K6855553AA INSTRUCTION SHEET 45RFE & 545RFE PUMP COVER - 52119859AA

K6855553AA -SMM - Instruction Sheet

THIS COVER 52119859AA:

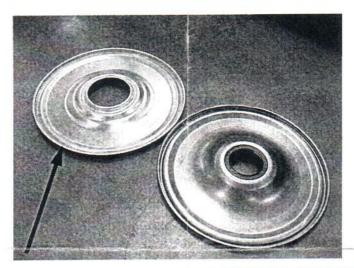
A running change was made to the 45RFE / 545RFE transmission pump and pump cover during the 2007 MY. The previous pump housing featured a machined front hub, with the torque converter seal pressed into a bore in the hub. The pump cover was made of aluminum and featured a large ID with a square-section inner seal, and was retained by two snap rings (at the ID and OD).

The new pump design has no front hub. The torque converter seal is pressed into a steel pump cover, and the cover is retained by an outer snap ring only. No inner snap ring is used.

OLD COVER 04799609:

- Aluminum material
- Large ID

- Steel material
- T/Conv seal at ID

THIS PACKAGE CONTAINS THE NEW-DESIGN PUMP **COVER 52119859AA**. YOU SHOULD COMPARE THE PUMP COVER FROM THE FAILED TRANSMISSION WITH THE PICTURE ABOVE. IF YOUR TRANS CONTAINS AN OLD-STYLE COVER, THIS IS **NOT** THE CORRECT PART AND YOU MUST ORDER **04799609** INSTEAD!

NOTE: The new-style pump housing and pump cover <u>CAN</u> service previous model years, <u>IF</u> they are installed as a set. RFE pump kits (which include the pump assembly AND pump cover) may now contain the new-design parts. They can be used to service older transmissions IF the pump assembly and cover are installed as a set.
